**Memorandum**

**Subject:** Additional Responses to DEIR Comments

The staff report the Commission received in Friday's packet summarizes several of the significant issues raised at the DEIR public hearing on January 12 for the Palo Alto/Stanford Development Agreement and Lease. In addition, staff has prepared the attached responses to other issues raised either in public testimony at the hearing or in written correspondence submitted at that time.

### POLE HEIGHT GLARE LIGHT IMPACT @ 150' FROM FIELD

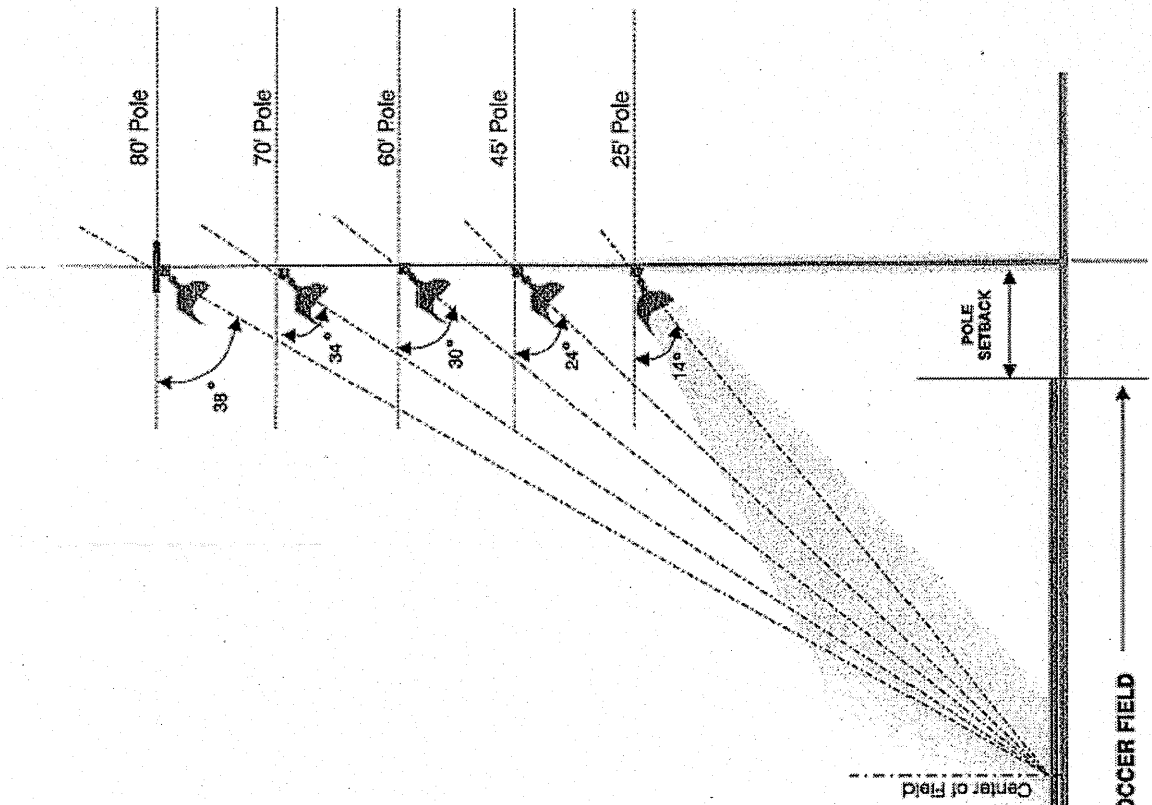
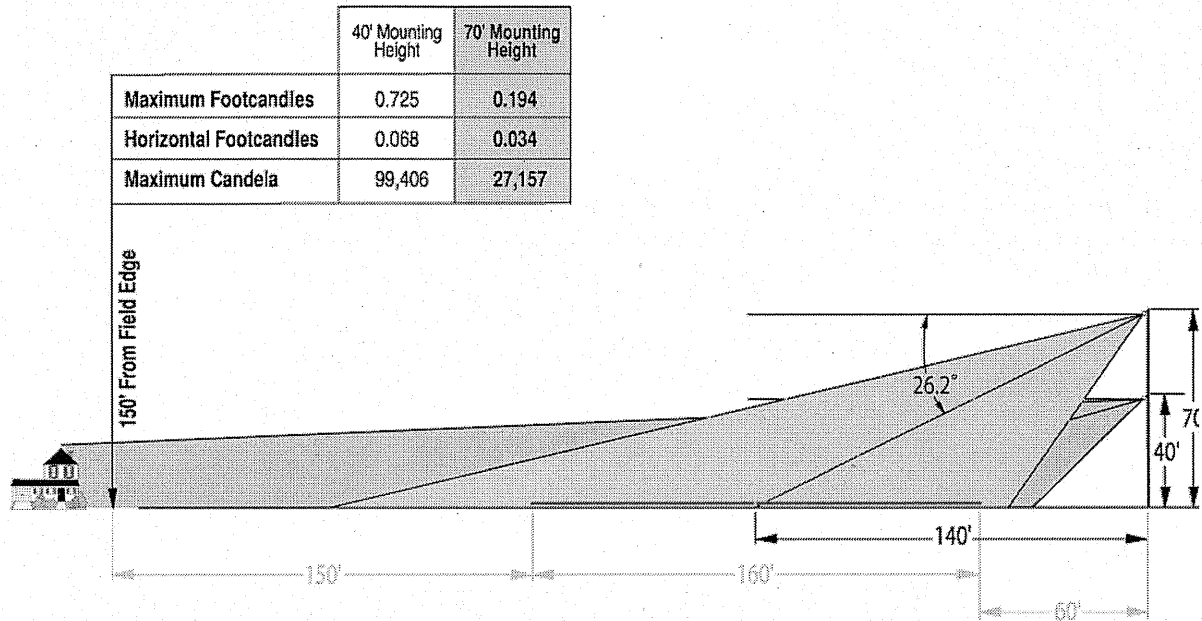
**1a,b, and c. The soccer field lights have the potential to create significant impacts. It is not clear why 70-foot poles are needed. Lights should be turned off lights at 10:00 pm not 11:00 pm. Glare impacts to drivers along El Camino Real and Page Mill Road.**

The 70-foot pole design is better for controlling light spill than poles of lower height. The 70-foot light poles allow for lighting of more surface area while minimizing to a greater extent spillover light beyond the site boundaries than light poles of lower height. The following diagrams help illustrate why taller poles are preferred. Given the proposed pole heights and manufacturer specifications for cutoff performance spillover/glare, light impacts would be less than significant; therefore, shutting lights off at 10:00 pm versus 11:00 pm is not necessary to reduce any impacts.

- As fixture mounting height is reduced, the resulting impact of off-site areas increases.
- As fixture mounting height is reduced, lighting visibility from a distance is greatly increased. Including the production of upward "sky glow"
- In addition, as pole heights are reduced the resulting quality of lighting on the playing field is also greatly reduced

POLE HEIGHT	GLARE LIGHT IMPACT @ 150' FROM FIELD
80'	< .50 footcandles = 27% approx. reduction from design
70'	.65 footcandles = off-site impact as designed
60'	1.00 footcandles = 54% approx. increase
45'	1.45 footcandles = 127% approx. increase
25'	> 3.00 footcandles = 670% approx. increase
